APPLICATION NO.	FILING DATE	FIRST NAMED INVENTOR	ATTORNEY DOCKET NO.	CONFIRMATION NO.
10/789,365	02/27/2004	Patrik Denoth	34097/US	5140
74307	7590	06/04/2009		
Dorsey & Whitney LLP IP Department, ATTN: Disetronic Licensing AG 50 South Sixth Street, Suite 1500 Minneapolis, MN 55402-1498			EXAMINER VU, QUYNH-NHU HOANG	
			ART UNIT 3763	PAPER NUMBER
			MAIL DATE 06/04/2009	DELIVERY MODE PAPER

### Office Action Summary

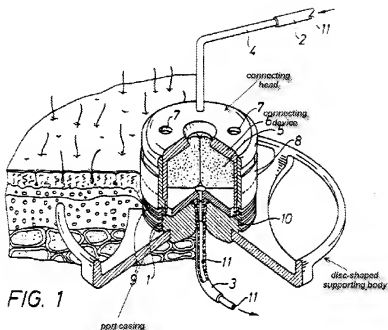
As best as understood, Svensson discloses a port system, comprising:

an implantable first fluid guiding system comprising a disc-shaped supporting body;

an external second fluid guiding system 4 with a connecting head at one end;

a percutaneously implantable port for establishing a fluid connection between said fluid guiding systems, said port comprising a port casing 8, which forms a first connecting element;

and a connecting device which comprises a second connecting element on an upper side of the connecting device;

wherein said connecting head is fastened to said port casing by a releasable fastening engagement of said connecting elements;

wherein the connecting head comprises a connecting cannula 3 and said connecting cannula and at least one connector region of the first fluid guiding system, guided into the port casing, exhibit the same flow cross-section, in order to avoid or at least minimize turbulence in the fluid;

wherein the first fluid guiding system feeds in or into the port casing, flush with said connecting cannula, in order to avoid or at least minimize turbulence in the fluid at a transition between the connecting cannula and the first fluid guiding system.
